DA number: 10.2020.513.1

Subject address: 84 Harbour Way Brunswick Heads

Objection to Alterations and Additions to Existing Motel including Five (5) Additional Guest Rooms, Restaurant/Bar, Swimming Pool and Car Parking Spaces, DA 10.2020.513.1 Lot 10 DP 805193 No. 84 Harbour Way, Brunswick Heads

First Floor

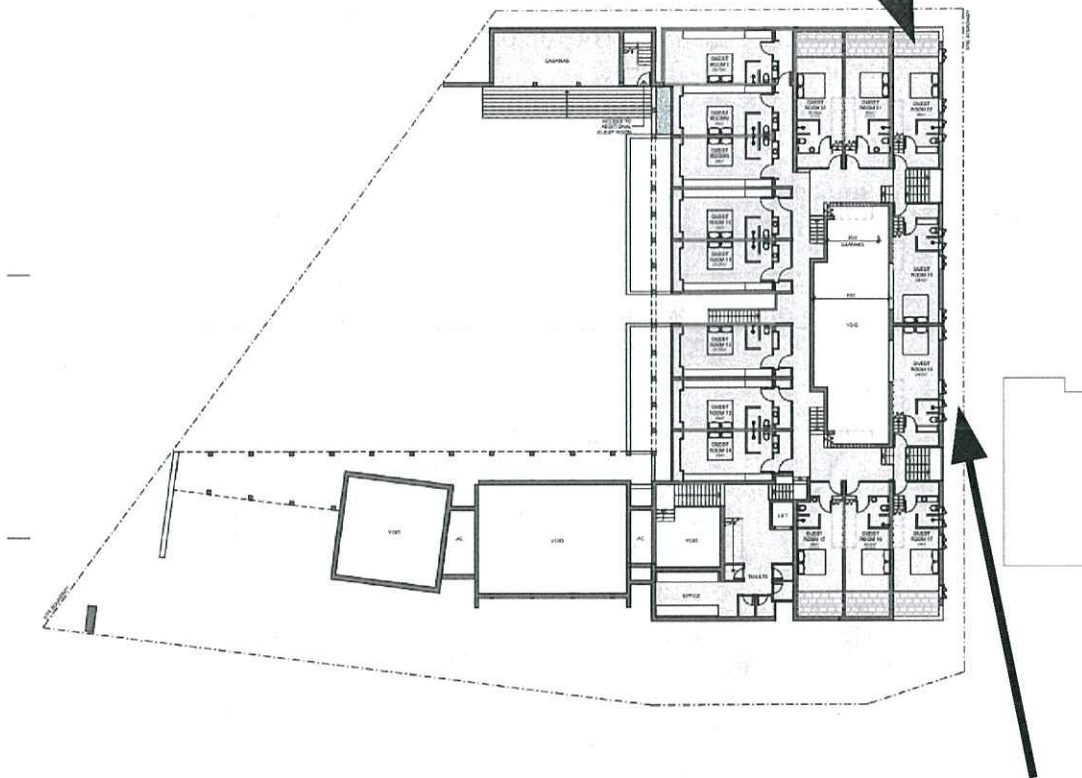
- Proposed First Floor Windows, and Private Patios sit directly adjacent to the residential buildings on the adjacent R2 Residential Zoned sites to the west.

This results in loss of privacy and significant amenity and overlooking impacts which also exacerbate noise transmission over a very short distance. This does not meet the Zone objective that Development in the B4 Zone should achieve **"compatible land uses"**.

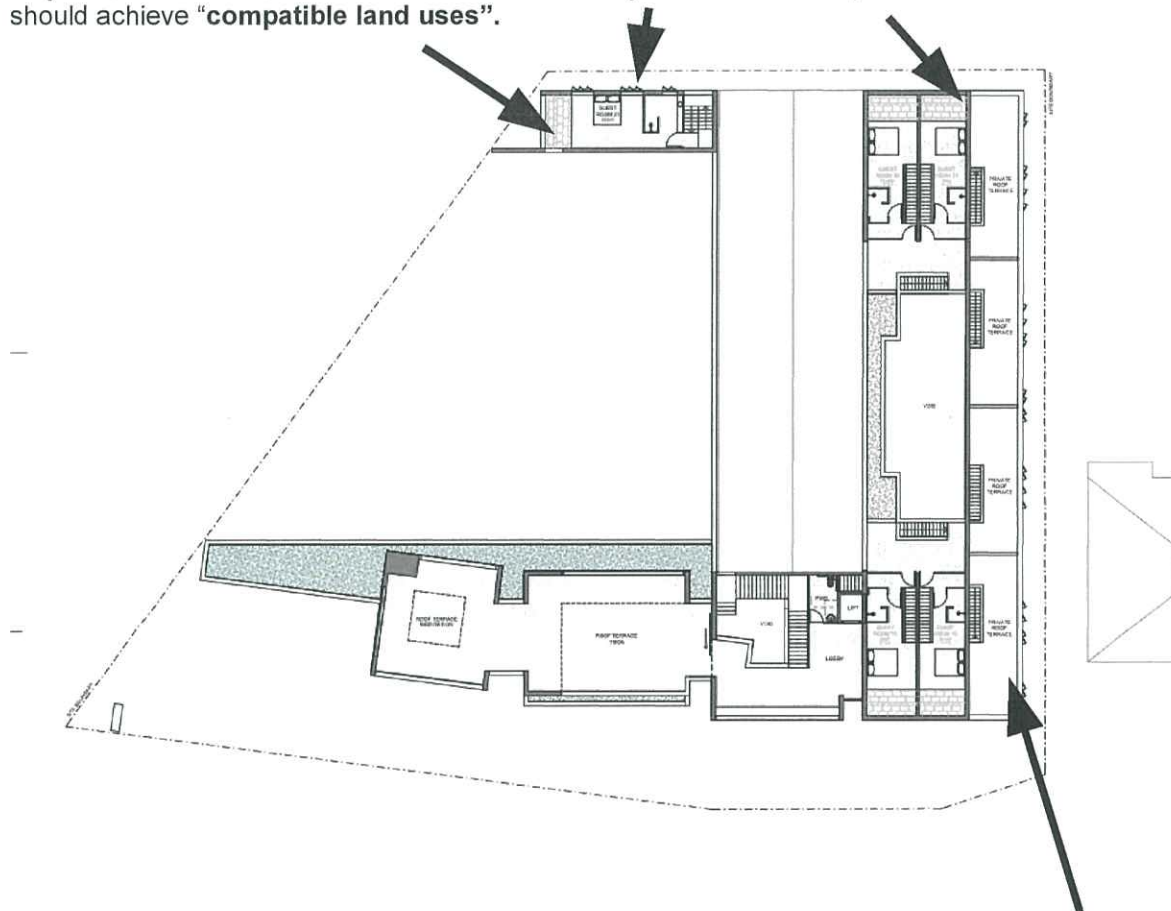
- Proposed First Floor Windows, and Private Patios sit directly adjacent to the residential building and their private yard on the adjacent R3 Residential Zoned site to the north.

This results in loss of privacy and significant amenity impacts relating to noise transmission over a very short distance, as well as overlooking. This does not meet the Zone objective that Development in the B4 Zone should achieve **"compatible land uses"**.

Second Floor

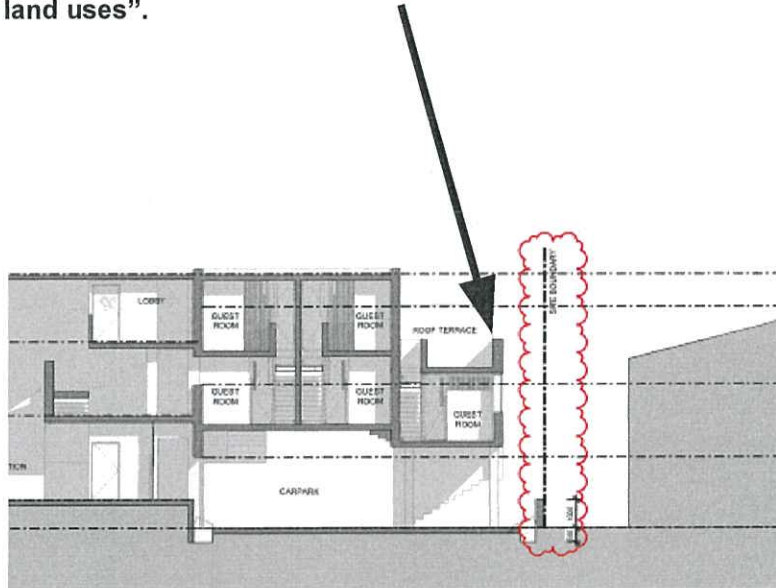
- Proposed First Floor Windows, and Private Patios sit directly adjacent to the residential building on the adjacent R3 Residential Zoned site to the north.

This results in loss of privacy and significant amenity impacts relating to noise transmission over a very short distance. This does not meet the Zone objective that Development in the B4 Zone should achieve “**compatible land uses**”.
